# DC SEAWATER PUMP INSTALLATION

PRODUCT DC SEAWATER PUMP, 30331

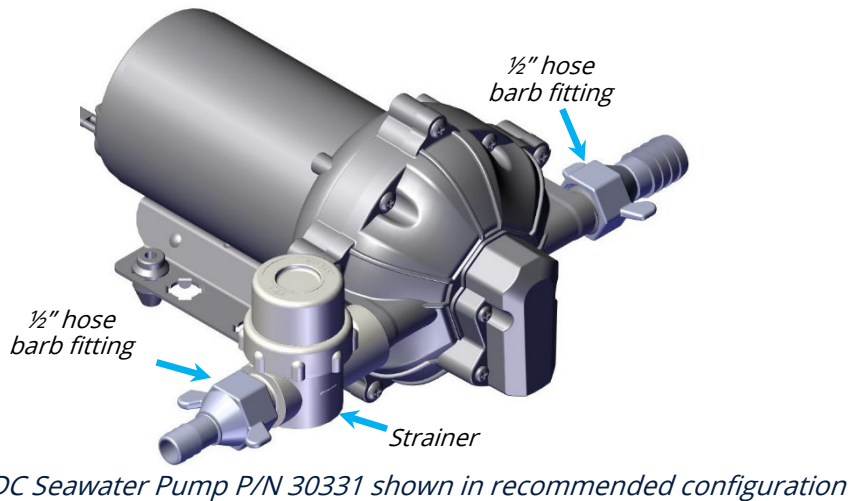
To notify Seakeeper installers of a peculiarity with SeaFlo® pump 30331 threads. The threads on the pump, strainer, and fittings supplied in the SeaFlo® pump assembly (P/N 30331) are not compatible with NPT fittings.

The DC Seawater Pump Assembly (P/N 30331), supplied by SeaFlo®, was previously described as having NPT threads. It has been determined that the threads are not NPT and are not compatible with tapered NPT fittings. Some installers have had issues when using standard NPT fittings to locate the strainer remotely from the pump.

The desired pump configuration is to locate the strainer (SeaFlo® part number 51S01) directly onto the pump's suction male threads. The inlet to the strainer and outlet of pump discharge should then use the barbed fittings provided in the kit (SeaFlo® part number 51F01 for ½" hose, or 51F08 for ¾" hose). A ½" hose barb 90° elbow is also available in the pump kit (SeaFlo® part number 51F03).

All components supplied in the 30331 assembly have the same thread and are compatible with one another. Only fittings supplied in the kit or equivalent replacements from SeaFlo should be used to connect to the pump and strainer. The pump may be mounted in any position. If mounted vertically, the pump head should be in the down position to avoid leakage into the motor casing in the event of a malfunction.
